**DEPARTMENT OF HEALTH**  
Contested Case Hearing Re Red Hill Permit Application  
19-UST-EA-01  
Supplemental Testimony of Curtis Stanley

1           This supplemental testimony was prepared in response to the Written Testimony of  
2   Nicole M. DeNovio (“Dr. DeNovio”) and the report incorporated into that testimony entitled  
3   “Evaluation of Hydrology, Groundwater Flow and Contaminant Fate and Transport,” both of  
4   which are dated December 29, 2020 (collectively, the “DeNovio Testimony PDF”).  
5   Dr. DeNovio’s report and testimony contain errors that lead to incorrect conclusions regarding  
6   site conditions and environmental protectiveness. The details related to the Navy’s review of  
7   Dr. DeNovio’s report and associated inaccuracies are provided in Table 1. This table is formatted  
8   to describe particular issues noted in her report along with a brief response describing errors and  
9   other concerns. The following testimony addresses these errors to show that:

**Figure 9:** PID Readings for Individual Tanks Showing Large Increase at Tank 5 Following the Tank 5 Release and Much Smaller Increases at Other Tanks.

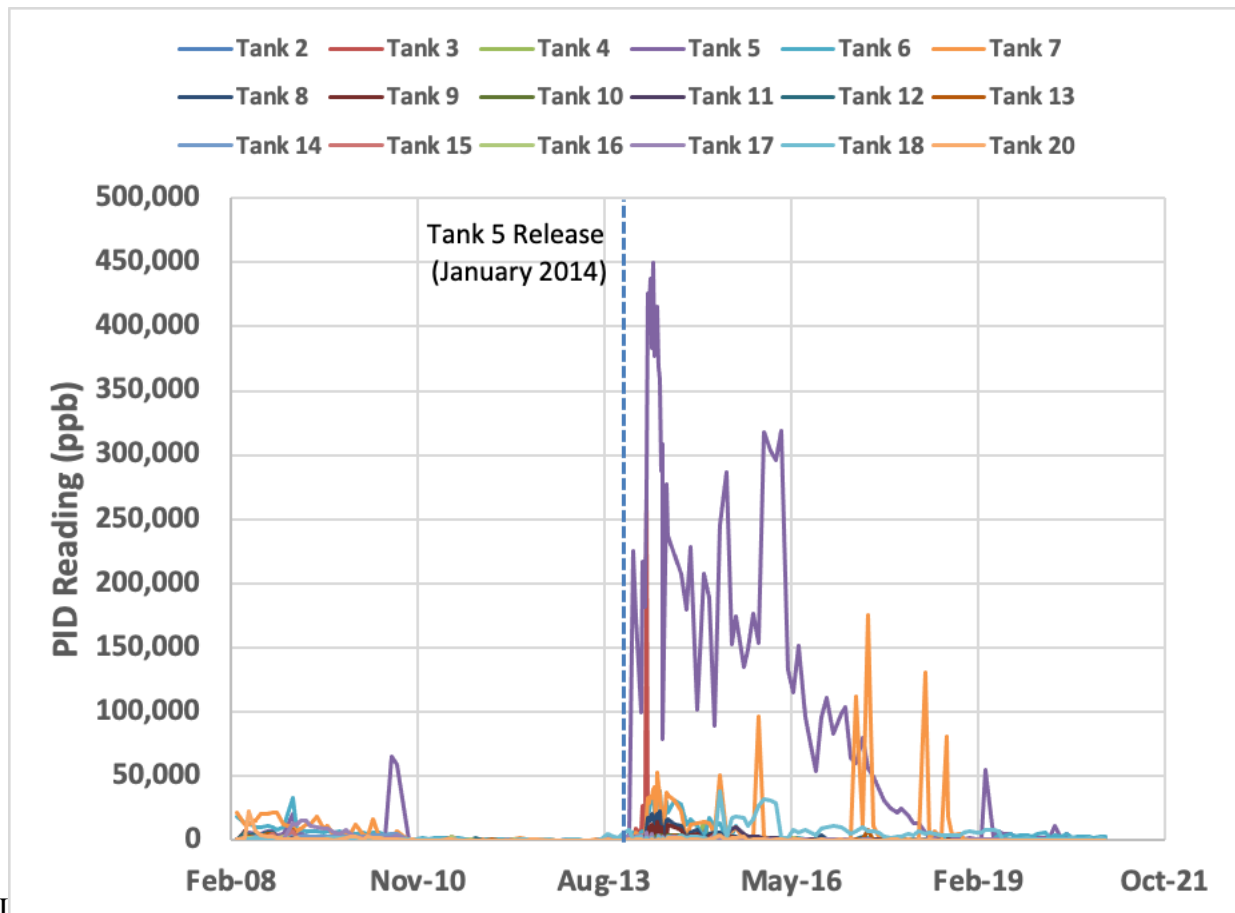
11 Dr. DeNovio's report uses a logarithmic scale, which hides differences in the reading  
12 between the tanks. Figure 9 in this response provides a to-scale depiction of the large  
13 differences in readings between Tank 5 and adjacent tanks.)

8 A described in the FER, soil vapor readings during the time period following the Tank 5  
9 release in January 2014 clearly showed a response to the release and demonstrated the  
10 utility of the monitoring network for release detection. From 2008 to 2013, the highest  
11 PID reading from any soil vapor monitoring point was 64,900 parts per billion (“ppb”).  
12 However, between January and May 2014, four different soil vapor monitoring points  
13 had PID readings above 100,000 ppb, demonstrating that a release can be identified as an  
14 increase in soil vapor readings. Furthermore, as shown below on Figure 7, soil vapor  
15 monitoring is just one of many layers of protection for release prevention, detection, and  
16 mitigation.
